**ENVIRONMENTAL VARIANCE REQUEST REVIEW SHEET**

**CASE:** C8-2010-0056.0B

**PROJECT NAME:** Regents West

## MEMORANDUM

## Site Plan Overview, with Variance Locations

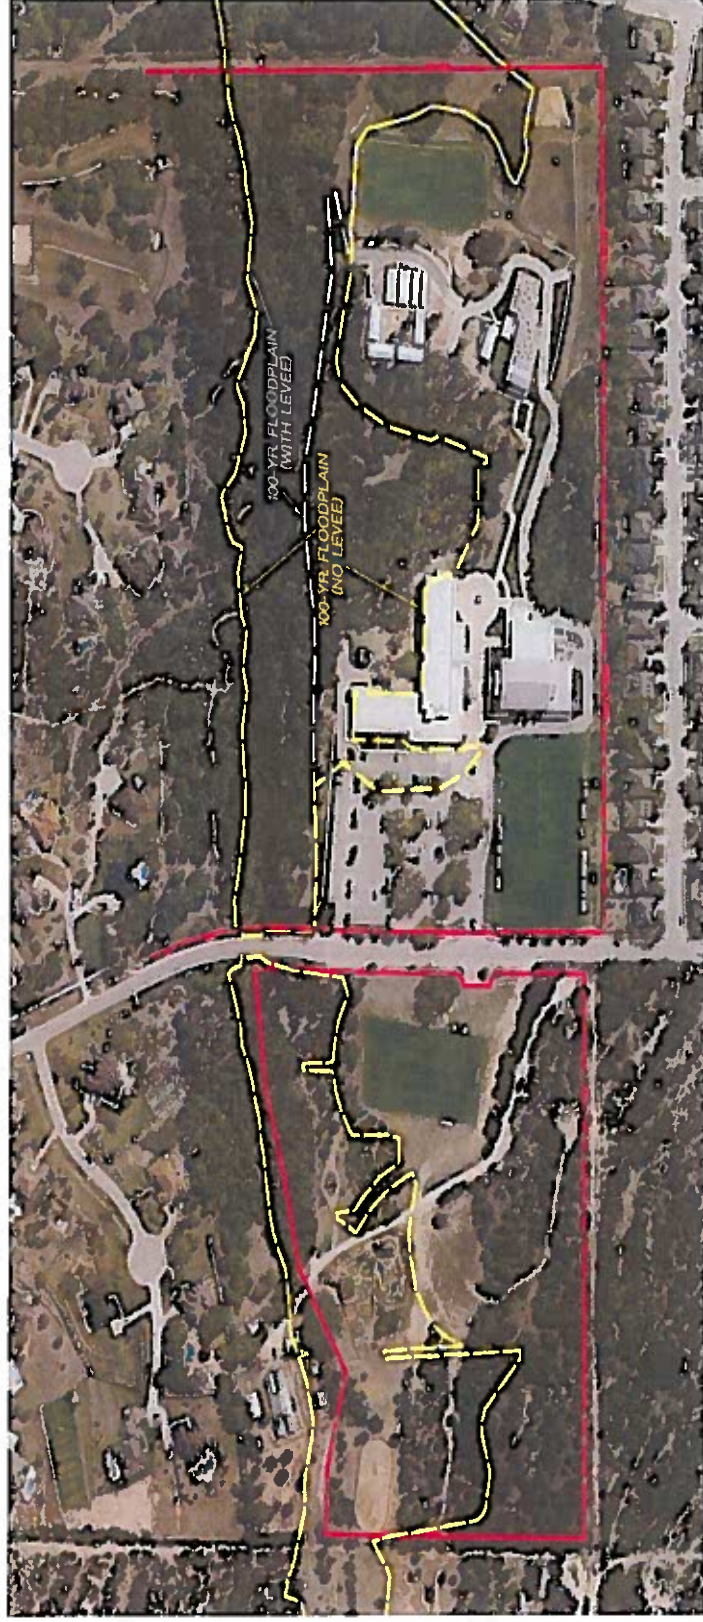
- Variance from LDC 25-8-482 to allow a floodplain modification berm to be constructed in the CWQZ
- Variance from LDC 25-8-483(A) (Recharge) to allow a floodplain modification berm to be constructed in the WQTZ
- Variance from LDC 25-8-483(B) (Contributing) to allow a floodplain modification berm to be constructed in the WQTZ

- Variance from LDC 25-8-341 to allow Cut up to a maximum of 14.5 Feet
- Variance from LDC 25-8-342 to allow Fill up to a maximum of 7.2 Feet

- Remove corral, greenhouse and portion of road in the CWQZ and WQTZ
- Natural seeding/landscaping for all disturbed areas with 609s in CWQZ areas (not road)
- Restore/revegetate in the area where the road is removed within the CWQZ and WQTZ
- Provide for silt fencing for erosion controls with curlex matting as required by the City of Austin
- Provide 4:1 slope (3:1 is required) on creekside of berm to reduce erosion and velocity
- 6:1 slope on backside of creek
- Tree mitigation at 100%
- Provide an educational component to students as to how the school has handled the environmental concerns of this site.
